Planning Commission Memorandum

- To: Planning Commissioners
- From: John Hinzman, Community Development Director
- Date: November 9, 2020
- Item: Vermillion Acres Senior Housing Preliminary Plat, Site Plan, and Variance #2020-05 -Headwaters\Mint Development

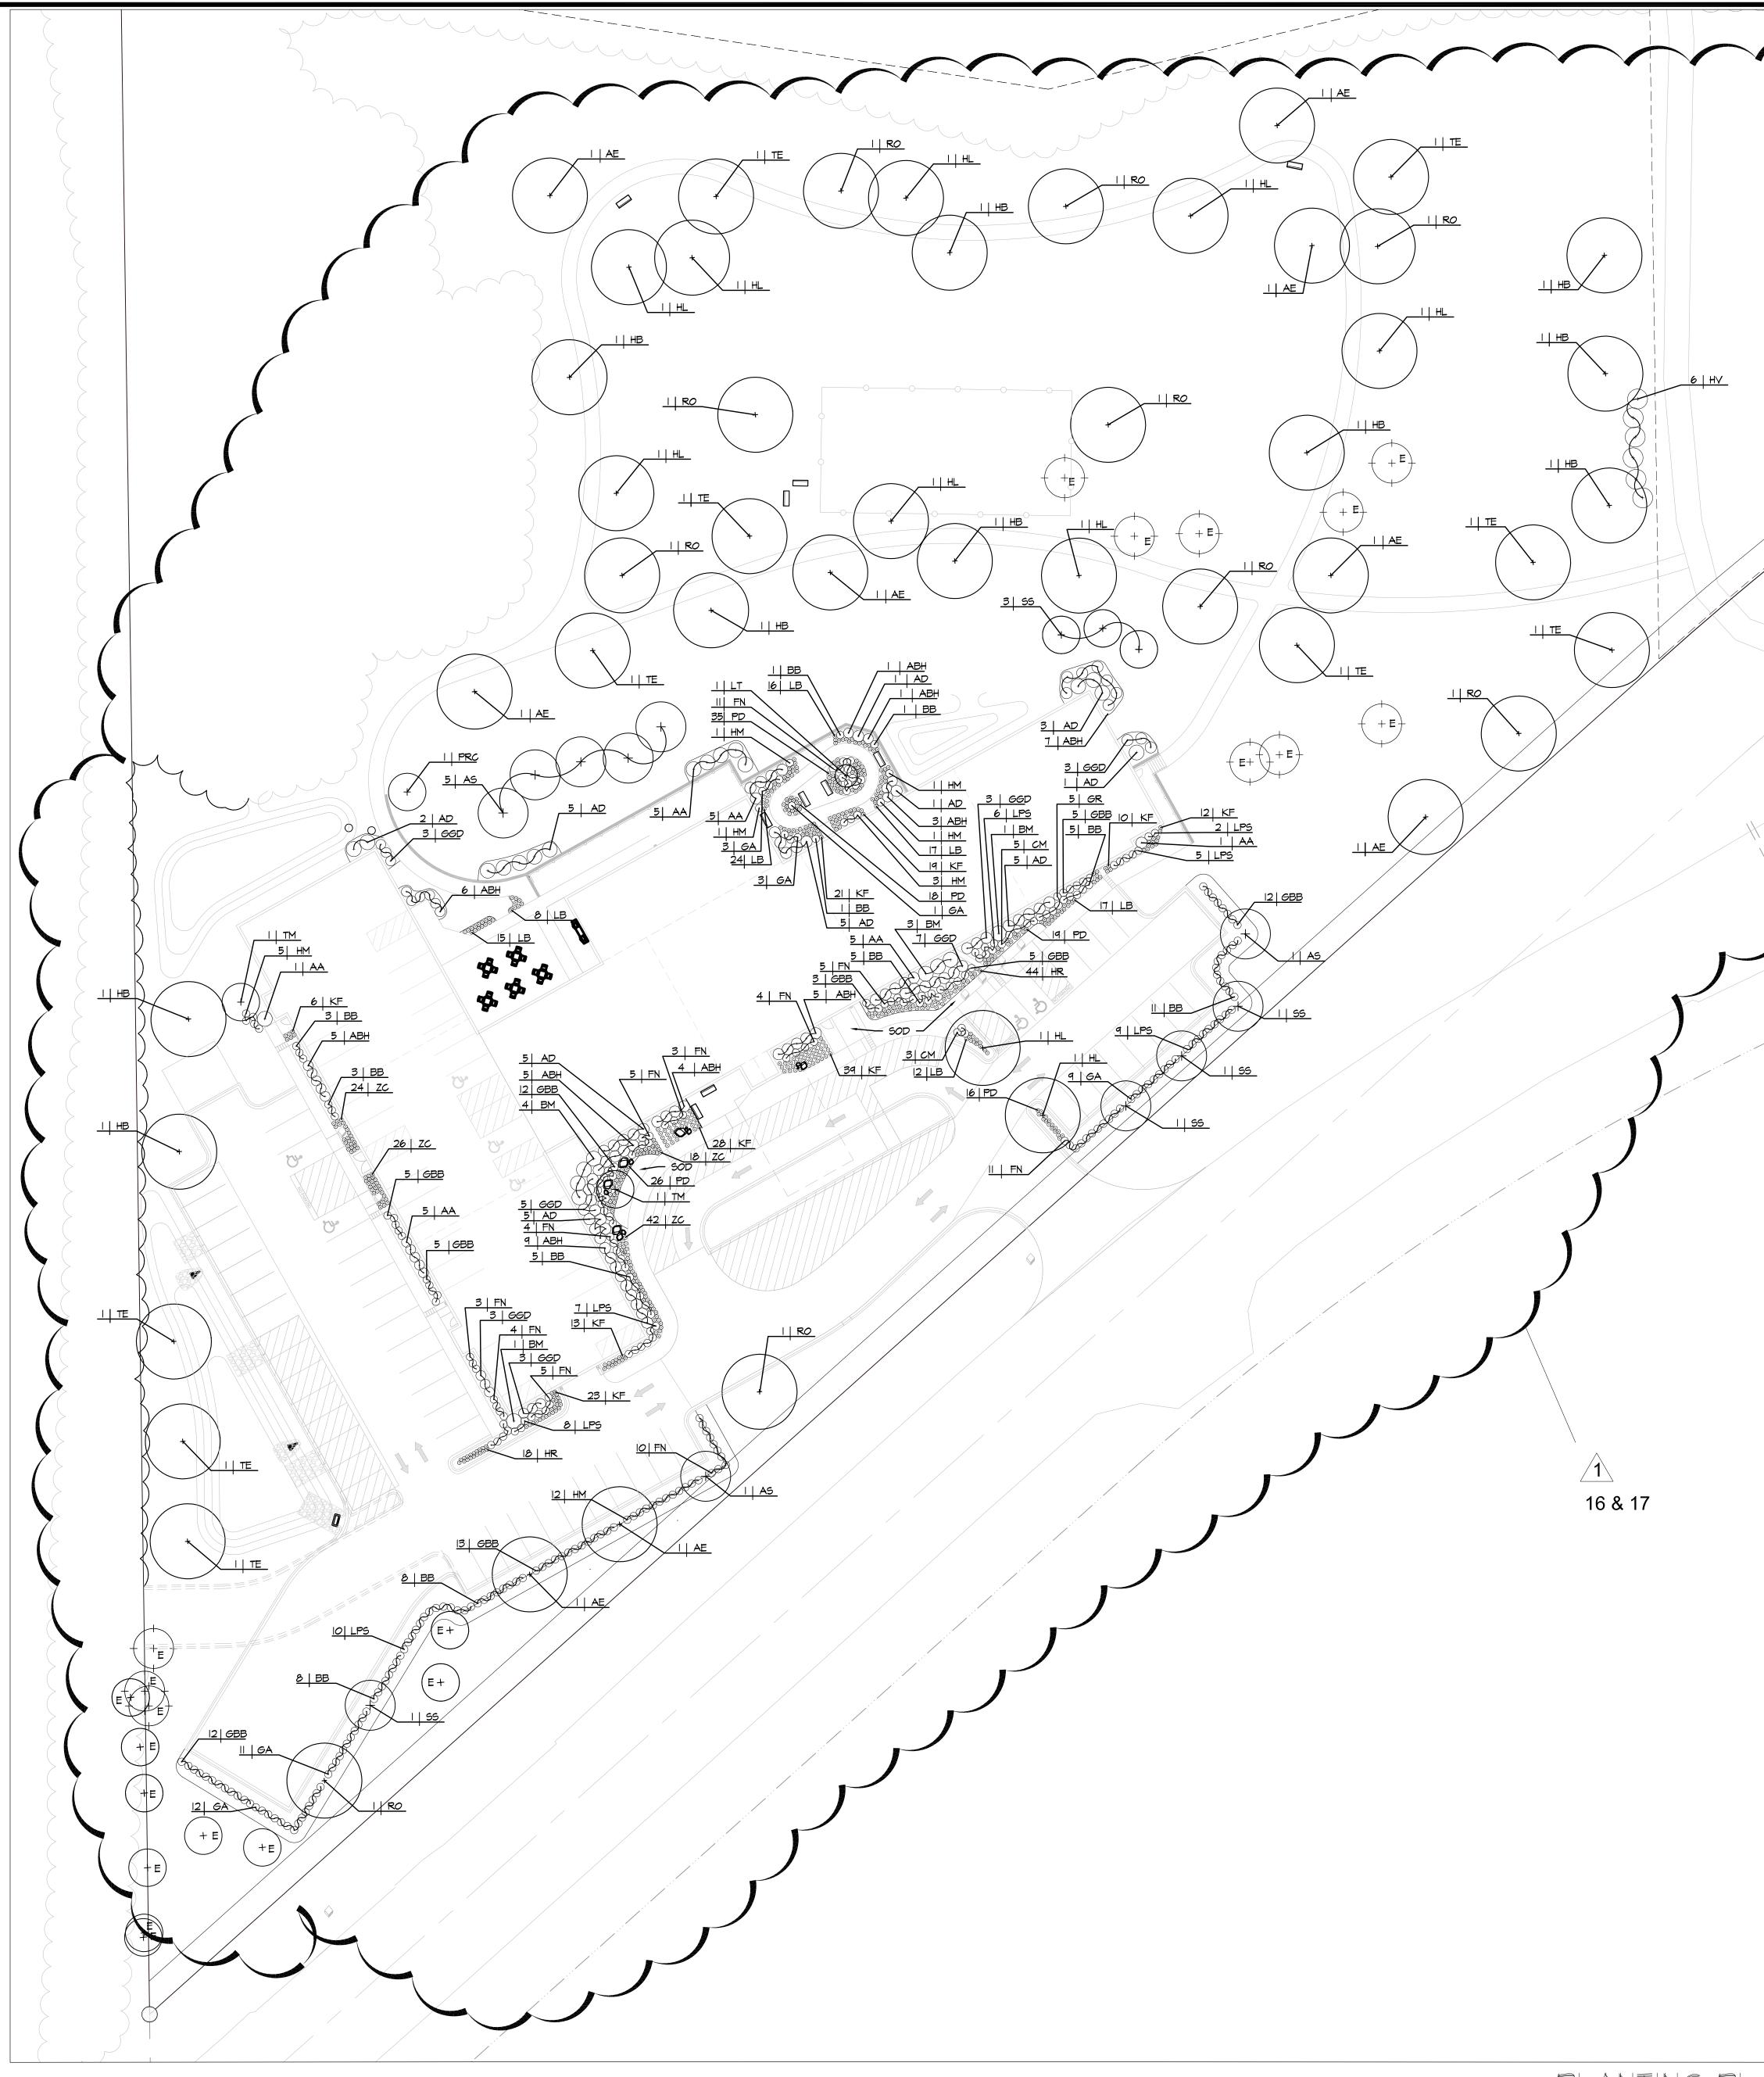
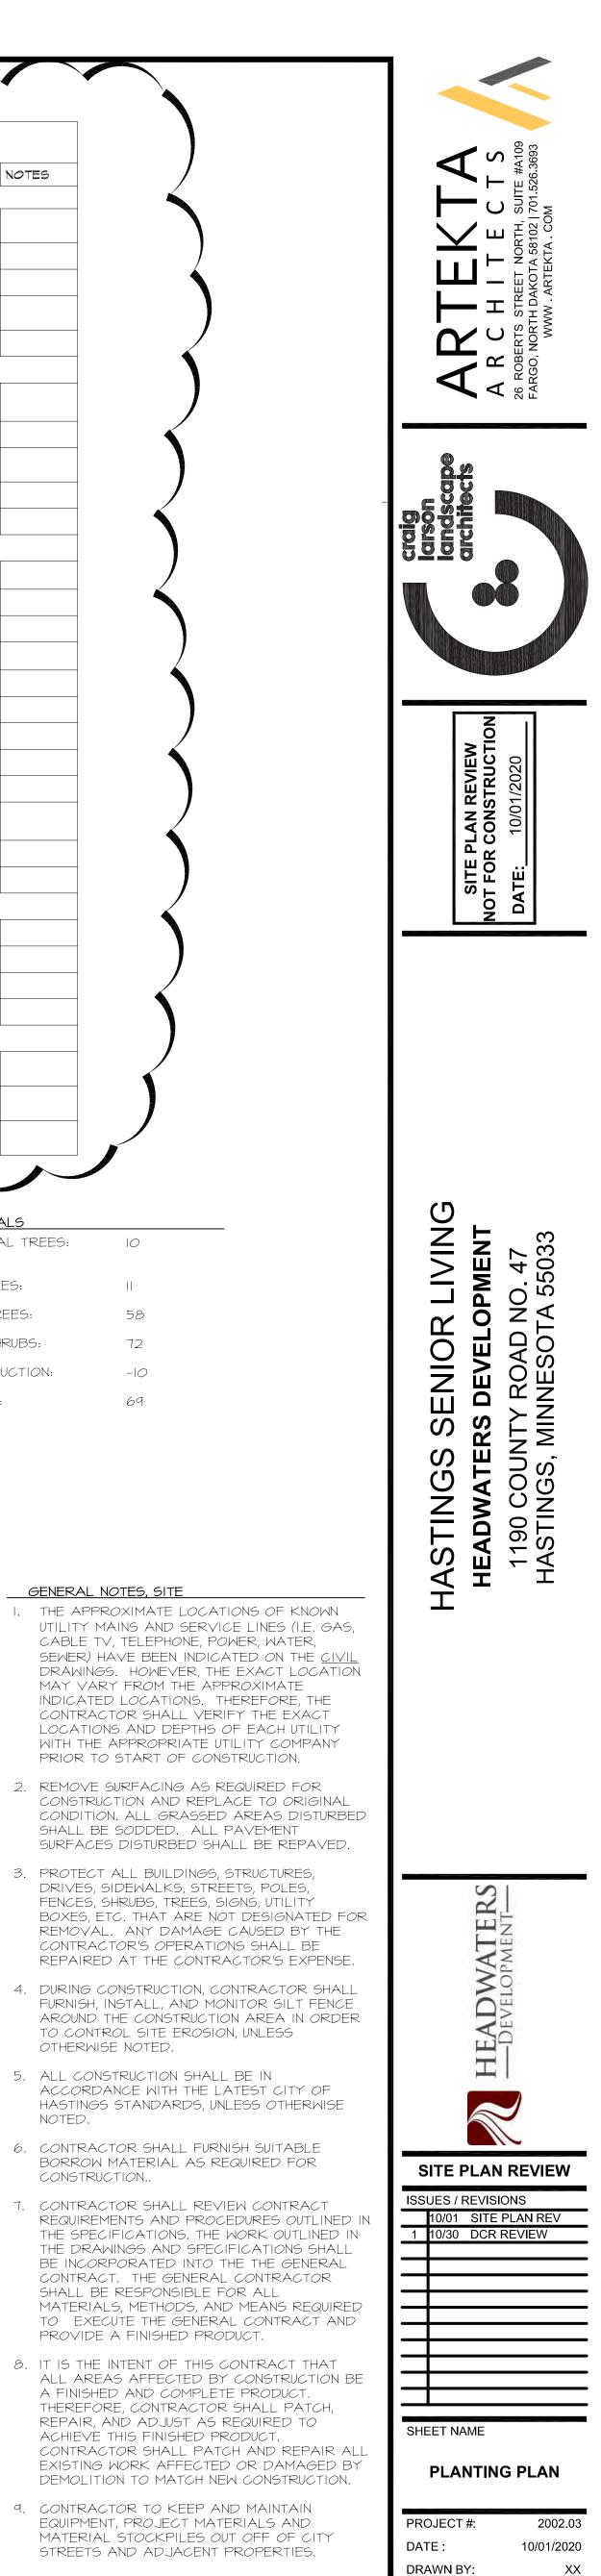
The Landscape Plan is acceptable with the following change:

1) An additional two trees must be added to the landscape plan to meet minimum plant quantity requirements.

- 3. Variance to the minimum 15 percent roof pitch requirement for Residential Care Facilities.
- 4. An additional two trees must be added to the landscape plan to meet minimum plant quantity requirements.
